INNER WEST

DEVELOPMENT ASSESSMENT REPORT

Application No.	DA/2020/0139
Address	40 Milton Street ASHFIELD NSW 2131
Proposal	Construction of a 6 storey residential flat building of 37 units, 50 car parking spaces including affordable housing units and strata subdivision.
Date of Lodgement	02 March 2020
Applicant	Habitation Design
Owner	Appwam Pty Ltd
Number of Submissions	Seven (7)
Value of works	\$9,426,636.00
Reason for determination at Planning Panel	Clause 4.6 variation exceeds 10%
Main Issues	Waste Collection, non-compliance with ADG, Variations to Development Standards, VPA for land dedication has not been completed
Recommendation	Refusal
Attachment A	Reasons for refusal
Attachment B	Plans of proposed development
Attachment C	Clause 4.6 Exception to Development Standards – Height
Attachment D	Clause 4.6 Exception to Development Standards – FSR
Attachment E	Recommended Conditions of Consent
Attachment F	Urban Design Report

Figure 3 – Site Photo, Eastern Elevation of 380 Liverpool Road and Milton Lane View.

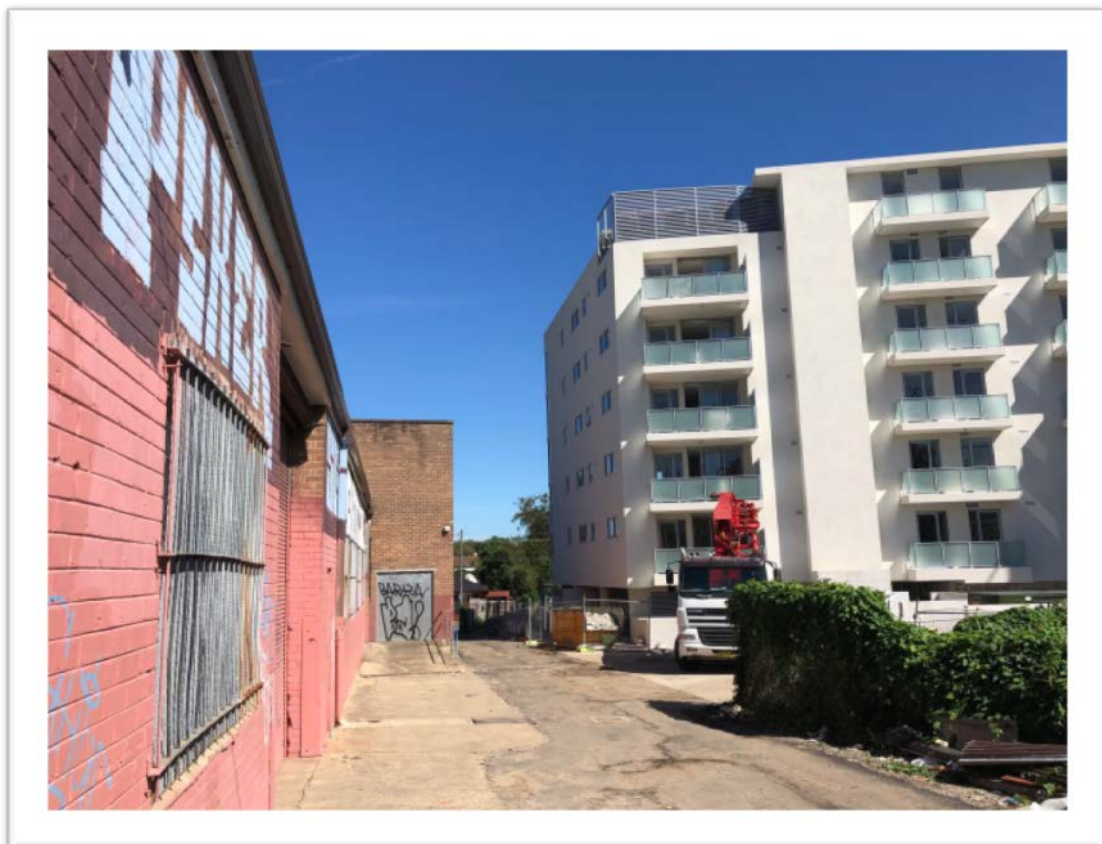
Analysis of the proposed northern boundary has highlighted that the development seeks consent for a 1m setback across all levels of the proposal. This boundary directly adjoins Milton Lane and results in a minimum 9m separation distance from the adjoining mixed-use development at 380 Liverpool Road. A review of the site photo replicated in figure 2 below highlights that openings to the southern boundary of 380 Liverpool Road generally relate to windows where openings have been kept to a minimum, while figure 3 shows the eastern elevation of 380 Liverpool Road where balconies have been located.

In this instance requiring an increased setback from the northern boundary is expected to provide little improvement to privacy but will result in additional shadow impacts to sites located to the south and a loss of public domain activation/interface to Milton Lane. The proposed setbacks along the northern boundary are considered to meet intention of the separation distances and ensures a degree of usable open space, landscaping, sunlight and privacy which would not be substantially improved through an increase to the setbacks.

Figure 4 – Blue line indicates applicants proposed path of travel for Council Waste collection, site identified by blue box.

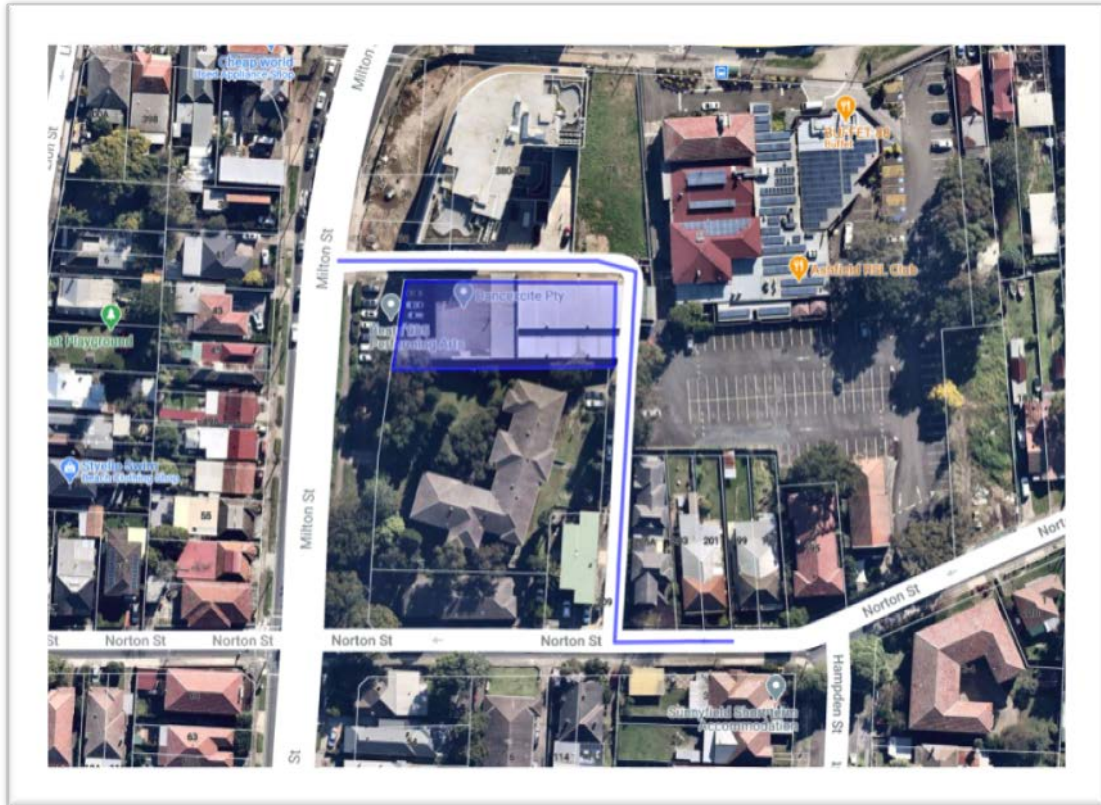
Documentation supplied by the applicant with regards to procedures regarding waste collection currently outline that bins are to be collected from Milton Lane, with trucks entering from Norton Street and exiting on Milton Street (path demonstrated in figure 4 below). Upon request from Council the applicant has provided swept path diagrams of trucks turning from Norton Street into Milton Lane, see figure 5 below. These swept path diagrams are based on the smallest trucks Council has servicing the Ashfield Area (9.4m long and weighing 26 tonnes). As seen from the provided swept paths in figure 5, Council garbage trucks are unable to make the Norton Street – Milton Lane turn without substantially encroaching onto private property. This matter has been reviewed by Council's Engineers who outlined that such a manoeuvre is not supported.

Alternative solutions such as trucks turning from Milton Street onto Milton Lane result in further complications with the site unable to accommodating a turning bay to allow for a truck to turn around and exit from Milton Lane onto Milton Street in a forward direction. This leaves only two remaining possible outcomes; the first being trucks enter Milton Lane from Milton Street, collect waste then reverse out onto Milton Street and the second being waste collection occurs from Milton Street. Both of these options are considered to be wholly unacceptable due to potential safety impacts and significant impact to the efficiency and operation of the Milton Street classified road. The proposal is therefore recommended for refusal as it has not been demonstrated that the development is compliant with clause 101 of the SEPP and that the site is able to be properly serviced.

SCALE @ A1: 1:50
SCALE @ A2: 1:100
DRAWN BY: NJM
DATE: 24/07/2020
CHECKED BY: JP
PROJECT NUMBER: 18 095
SHEET NUMBER: C117

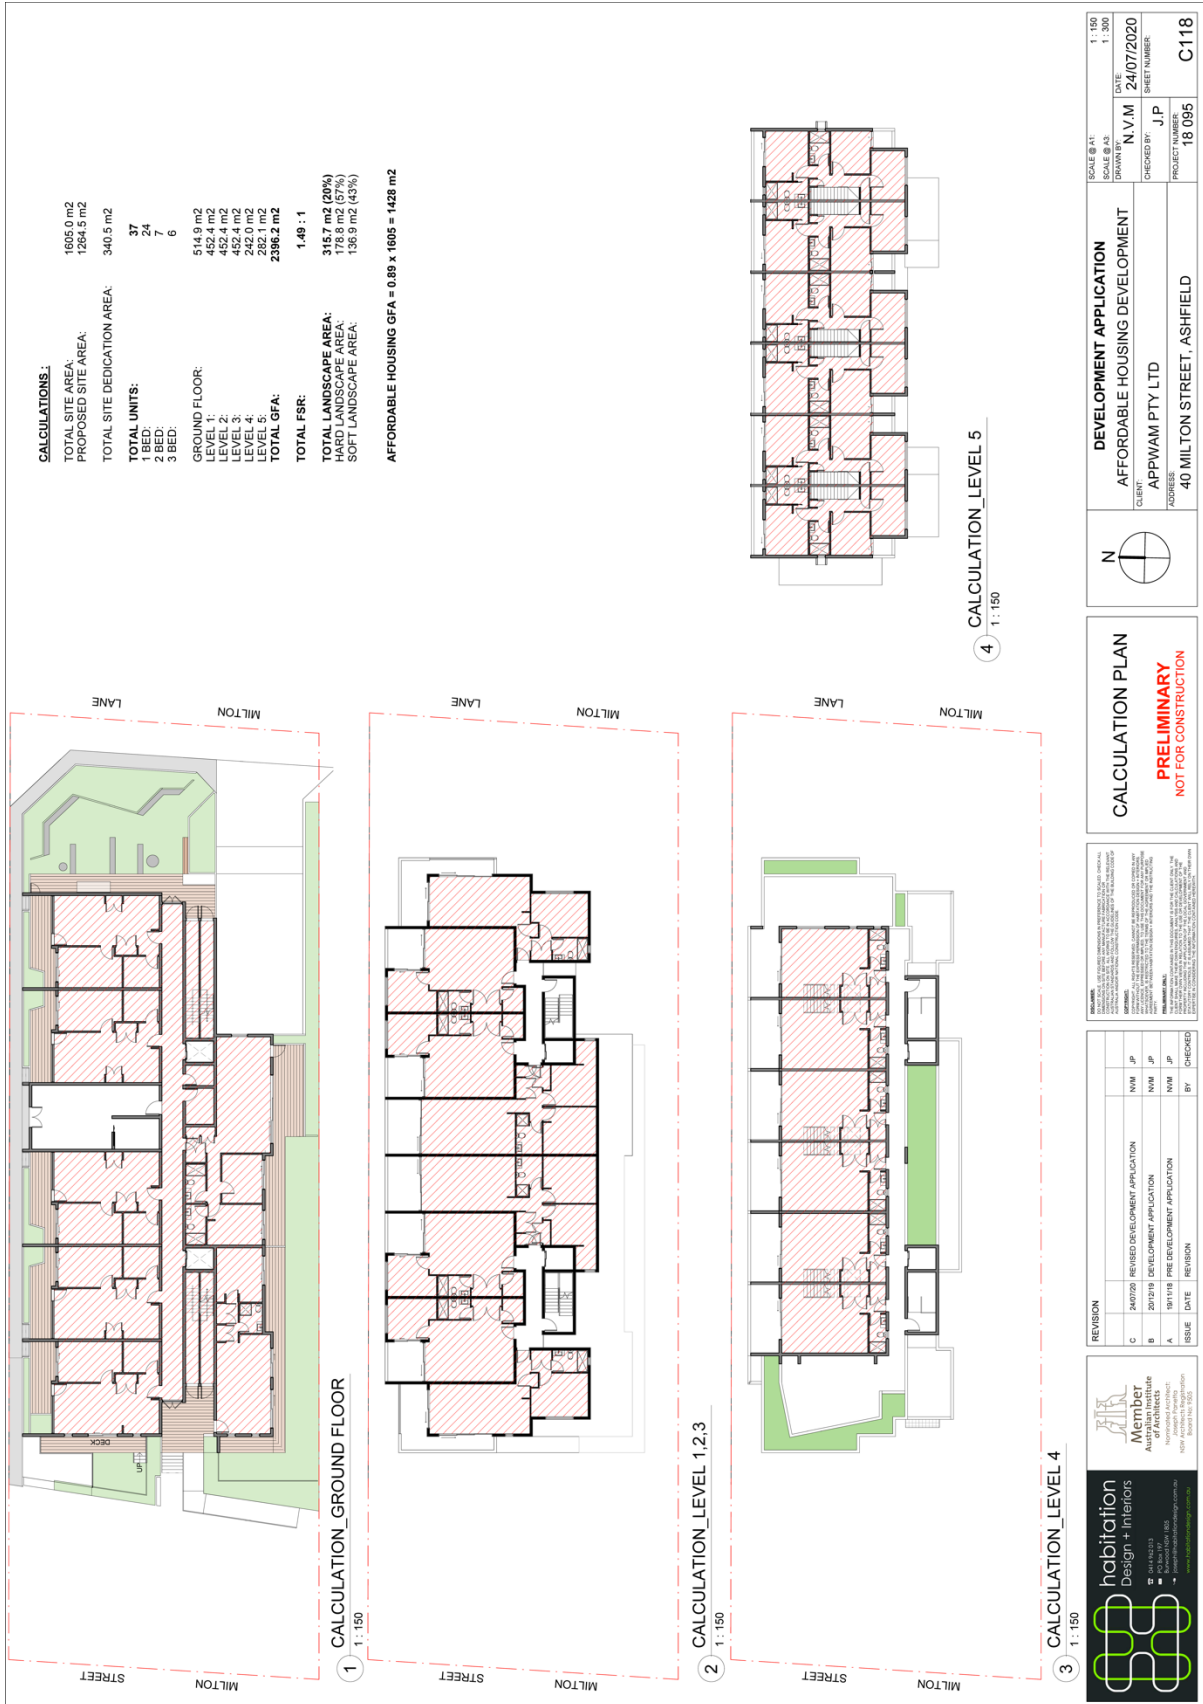
A review of the cross ventilation diagrams provided by the applicant has highlighted that less than 60% of the proposed apartments will be naturally cross ventilated in accordance with the requirements of the ADG. The diagrams detail that ventilation is achieved leaving the front door of units open or by requiring small bathroom or highlight bedroom windows to remain open. This does not satisfy the ADG which requires (for effective cross-ventilation):
